DEVELOPMENT DETERMINATION PANEL MEETING

WEDNESDAY 24 JULY 2024

ITEM 3.1 DA2024/0661 - 14 DUKE STREET FORESTVILLE - ALTERATIONS AND ADDITIONS TO A DWELLING HOUSE

Figure 1: Building Height Contravention (non-compliance highlighted in red)

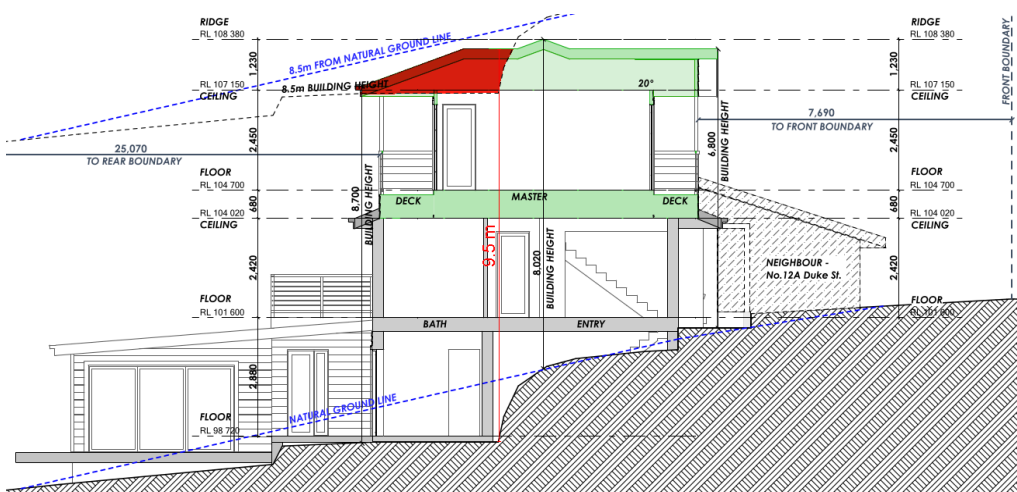
As such, the 'existing ground level' is taken to be the excavated point of the site on the lower ground floor. The new upper floor addition is located 9.5m above the existing ground level, which represents a 11.76% variation to the development standard. The extent of the contravention is depicted in **Figure 1** below.

It is important to note that when extrapolating the ground levels around the existing building footprint, in accordance with the NSW Land and Environment Court Case of *Bettar v Council of City of Sydney [2014] NSWLEC 1070*, the maximum building height would be 8.3m, thereby compliant with the height standard.

Figure 2: Side building envelope breach on southern elevation

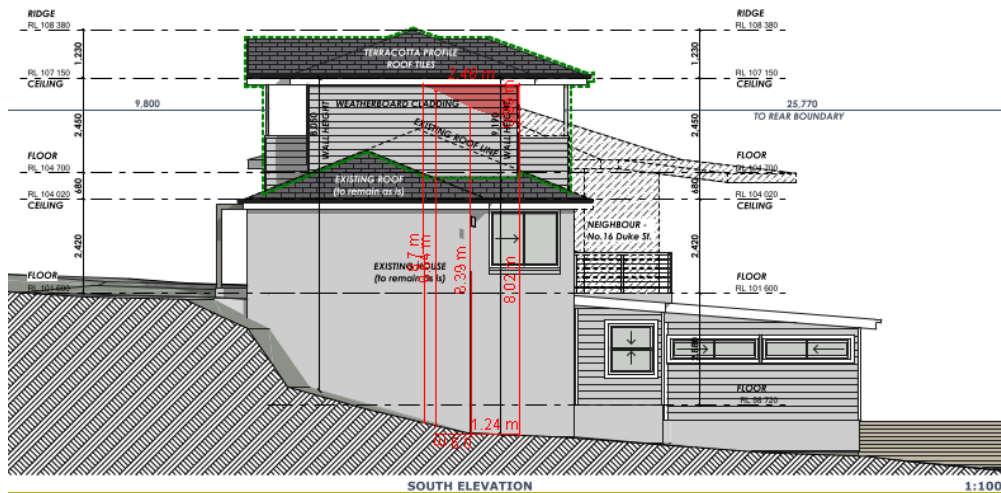
The upper floor addition includes a partial breach to the side building envelope control, occurring for a horizontal distance of 2.46m to a maximum height of 0.99m (see **Figure 2**).

Figure 1: Section showing the extent of the breach

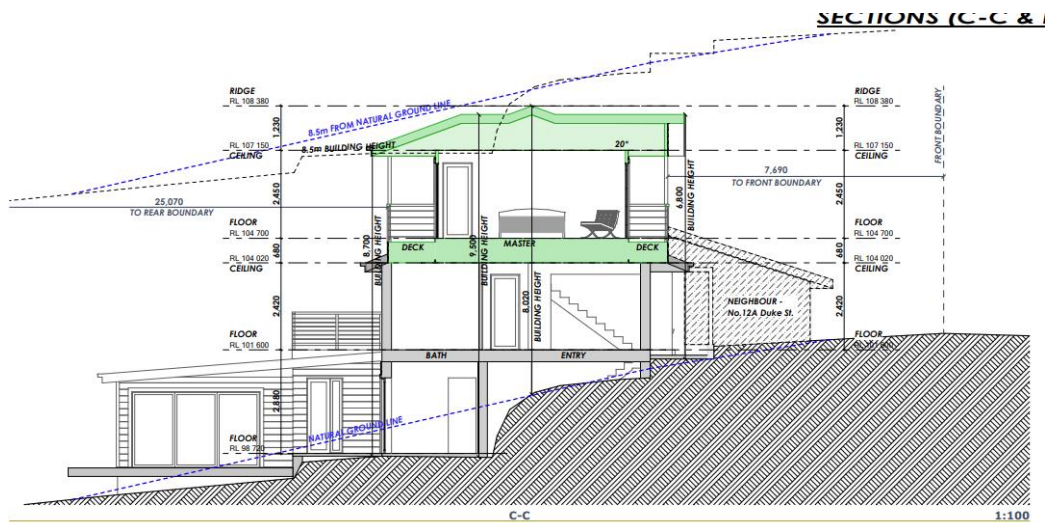
This request seeks a variation to the 8.5m height limit standard. The nature and extent of the variation is 1m which equates to a max building height of 9.5m. The breach represents an 11.76% variation to the development standard. The extent of the breach is shown on the elevation drawing extracts below.

Figure 2: Section showing both the extrapolated 8.5m plane and the 8.5m plane from existing disturbed ground levels

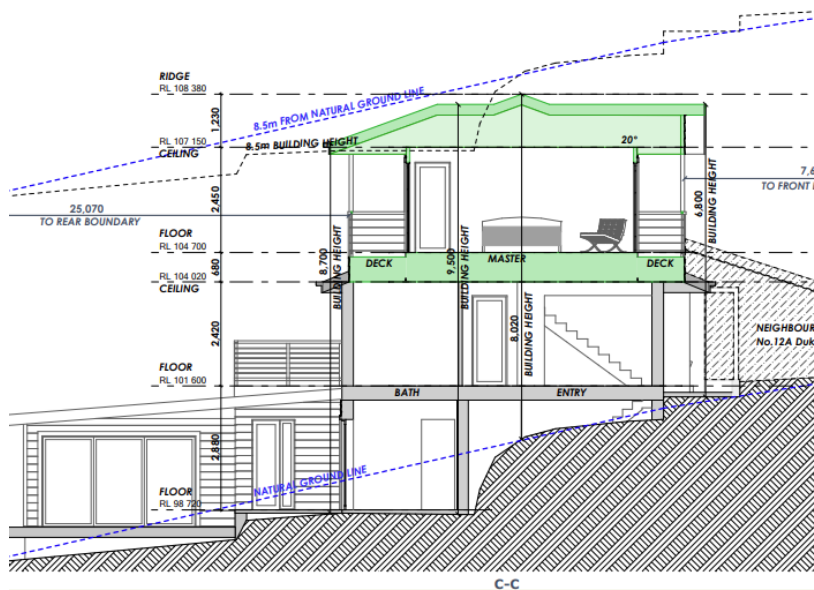
In this regard, I note that the prior disturbed levels of the site within the lower level distorts the height of buildings development standard plane overlaid above the site when compared to the natural undisturbed topography of the land. When the original undisturbed levels of the site are interpolated across the building footprint the proposed development would comply with the 8.5 metre height standard. This is demonstrated on the section drawing provided below which includes both the extrapolated 8.5m from natural undisturbed levels and the current method established by *Merman*.

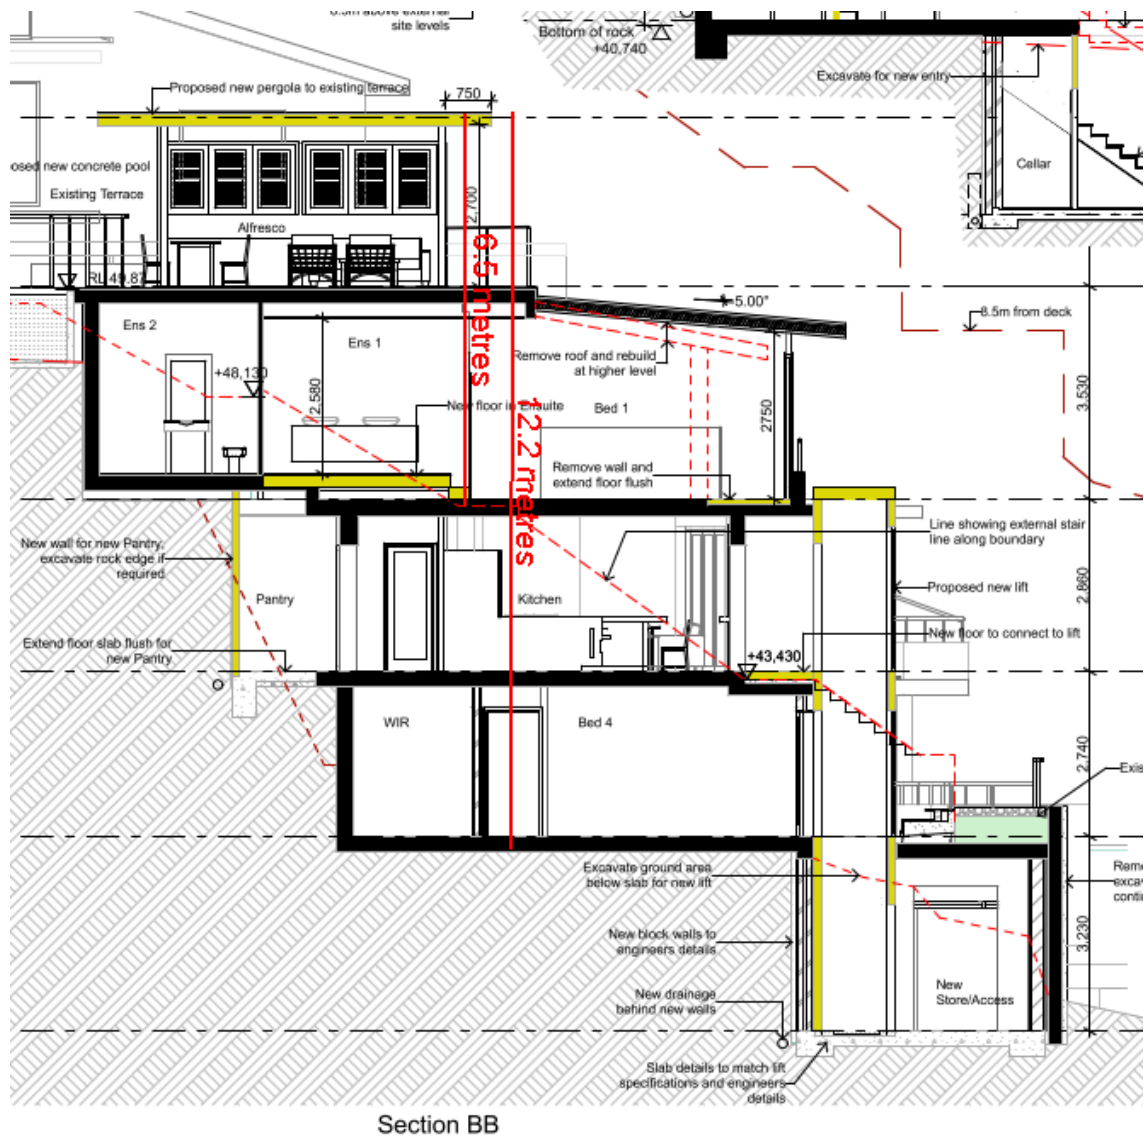
A representation of the building height measurement is provided below.

The measurement is taken from the level prior to the historical excavation (6.5m), as well as the measurement of Building Height in accordance with *Merman Investments Pty Ltd v Woollahra Municipal Council* [2021] NSWLEC 1582 (12.2m).

Figure 1. Extract of Section 1 showing Building height (red highlighting variation)

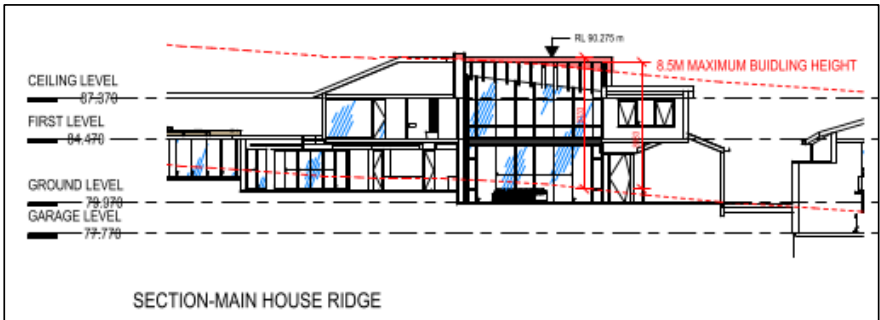
The proposed dwelling houses present a maximum building height of 9.333m (see Figure 1). Therefore, the proposal presents a variation of 9.8% (0.833m) to the required 8.5m control. Furthermore, the proposed dwelling house presents 8.98m floor to ceiling heights, presenting a variation of 24.72% (1.78m).

Figure 1. Proposed maximum building height, extent of breach indicated in pink.

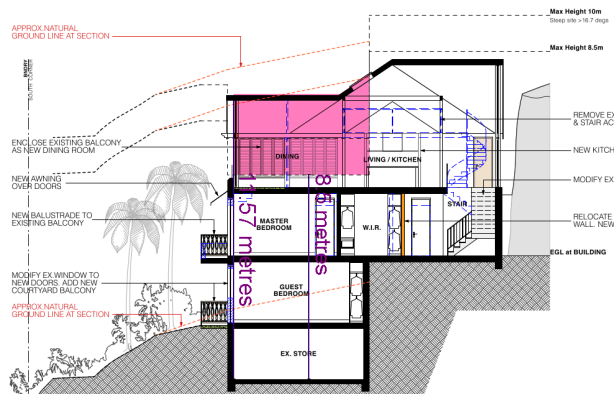
Percentage of variation: 36.1%

Figure 1 – North elevation (source: Hampton Architecture).

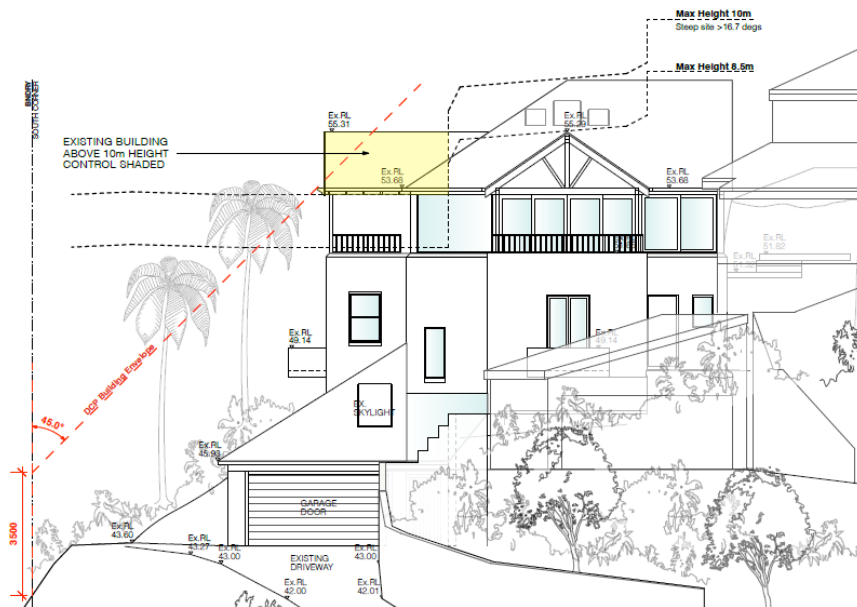
The breach to building height is depicted on the elevations in Figures 1 and 2 below.

Figure 1: Northern side boundary envelope non-compliance.

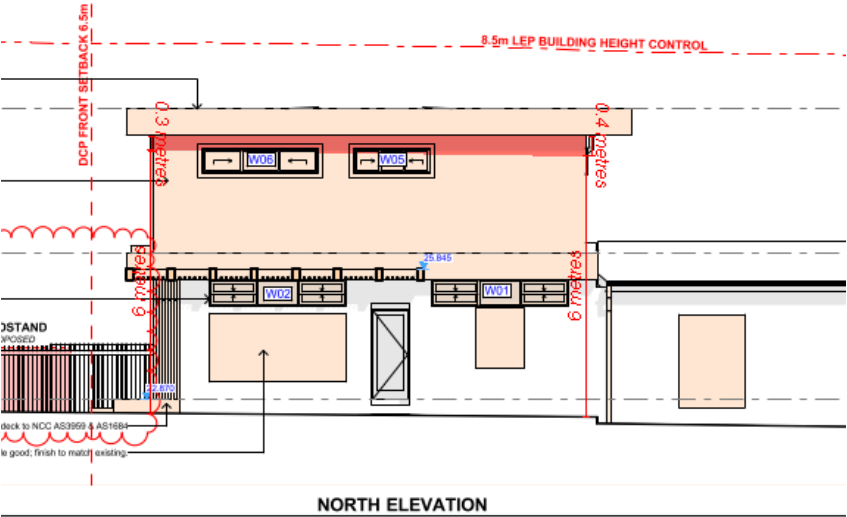
See the visual depictions of the side boundary envelope non-compliance below:

Figure 3: Proposed privacy screen on the south elevation plan.

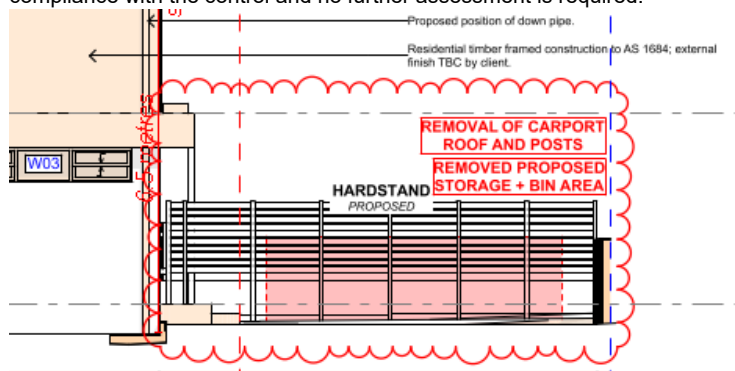
The plans submitted with this application have not resulted in the removal of the proposed privacy screen to the southern side boundary which represent the non-compliance to the control (see figure below). Therefore, a condition of consent to remove the privacy screen will apply to this application. The deletion of the privacy screen will result in compliance with the control and no further assessment is required.
